ITEM 4: 202004290020 – Beulah Park – Phase II (Development Plan)

A development plan for the Beulah Park Phase II roadway network and other site improvements.

Staff Recommendation

Approval with four stipulations.

Site Plan

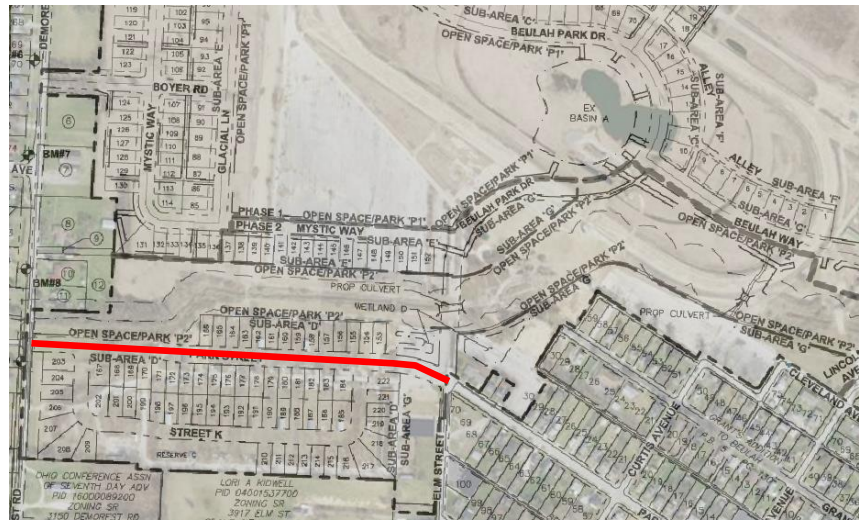
The development plan includes three extensions of existing public roadways and one additional public roadway. A traffic circle at the intersection of Park Street and Elm Street/Beulah Park Drive is being proposed as an informal entry feature and a traffic calming device, with a four way stop. Due to the angles of the roadways, oversized vehicles such as school buses and firetrucks will be permitted to turn left at the circle without going around the landscaped island in the middle. Signage indicating this traffic movement should be installed, to ensure traffic patterns and allowable deviations to these patterns are clear to motorists.

The location of mailbox CBUs has also been shown. The CBUs are proposed to be decorative and in character with other site fixtures within Beulah Park. The location of a CBU on the southern side of Street K is inconsistently shown between plan sheets. Staff recommends locating this CBU on the northern side of Street K or farther to the east, so that it is more incorporated with the residential lots, rather than along the frontage of the future Brookpark Middle School site.

Within the traffic circle at the intersection of Park Street and Beulah Park Drive/Elm Street, the applicant is proposing landscaping materials that include Crimson Pygmy Japanese Barberry, Karl Foerster Feather Reed Grass, and Blue Rug Juniper. Staff is recommending that the Karl Foerster Feather Reed Grass be replaced with an alternative species that will not grow tall enough to create line of sight issues at the intersection.

1. Applicant shall work with the Urban Forester to revise plant material within the Park Street traffic circle to ensure clear line of sight.
2. Appropriate signage shall be included in the Park Street traffic circle clarifying traffic movements and allowable deviations to traffic patterns for oversized vehicles (buses, fire trucks, etc.).
3. "No parking" signs shall be removed from the northern side of Street K.
4. All conspan crossings, for vehicular and pedestrian crossings, shall have stone facing similar to Beulah Park Section 1.

Beulah Park Drive (extension):

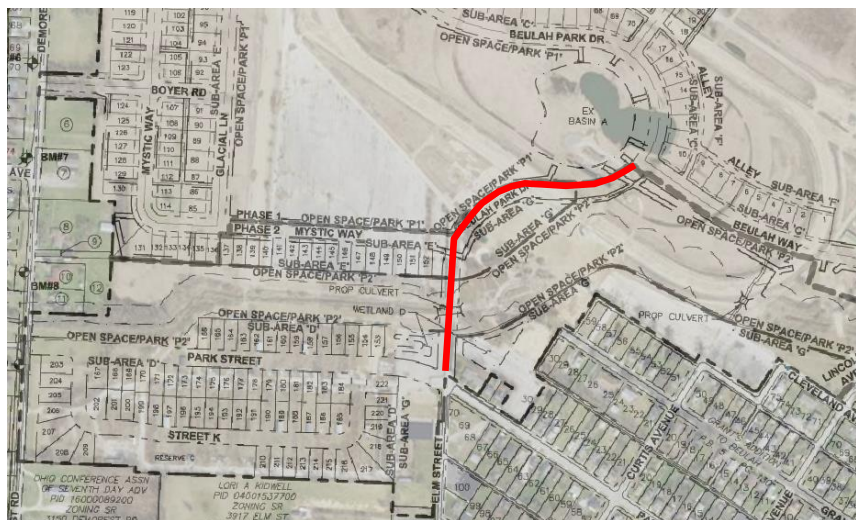
Beulah Park Drive is an extension of the roadway that was approved and constructed with Phase I. This extension borders the southeast side of the central park and connects at the intersection of Elm Street and Park Street. This street is classified as an “Avenue A” street type in the approved Beulah Park zoning text and subarea map. Beulah Park Drive has a 70’ right of way, with two (2) 12’ lanes, with on-street parking and bump outs on both sides of the street. Five (5) foot sidewalks are proposed on both sides of the street. The proposed street layout meets the requirements of the zoning text.

Mystic Way (extension):

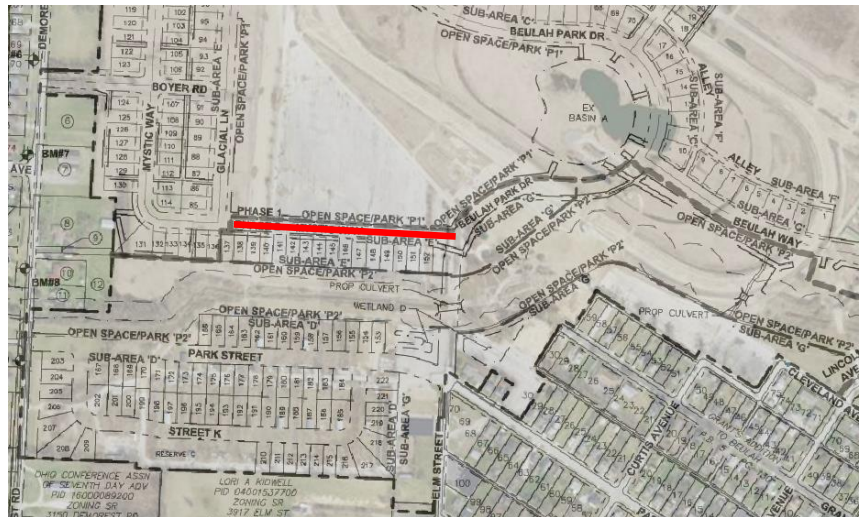
Mystic Way will be extended from its current terminus at Glacial Lane through to Beulah Park Drive. This street is classified as an “Avenue B” street type in the approved Beulah Park zoning text and subarea map. Mystic Way has 60-foot right of way, two (2) 12’ lanes, with on-street parking and bump outs on the side of the street that is adjacent to the park. Five (5) foot sidewalks are proposed on both sides of the street. The proposed street layout meets the requirements of the zoning text.

Street K:

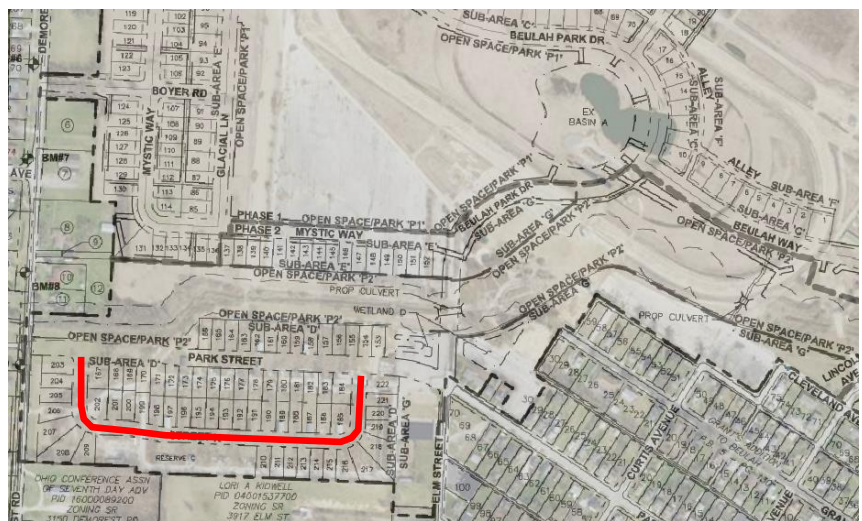
Street K is a looped roadway with two connection points on the future Park Street roadway. This street is designed as a “Local” street type. Street K has 60-foot right of way, two (2) 10’ lanes, and an additional 8 feet of pavement for on-street parking. Currently, the plans show “no parking” signs to be placed on both sides of the street. Staff recommends that “no parking” signs be removed from the northern side of the street, to meet the intention of the roadway design. Five (5) foot sidewalks are proposed on both sides of the street. The proposed street layout meets the requirements of the zoning text.
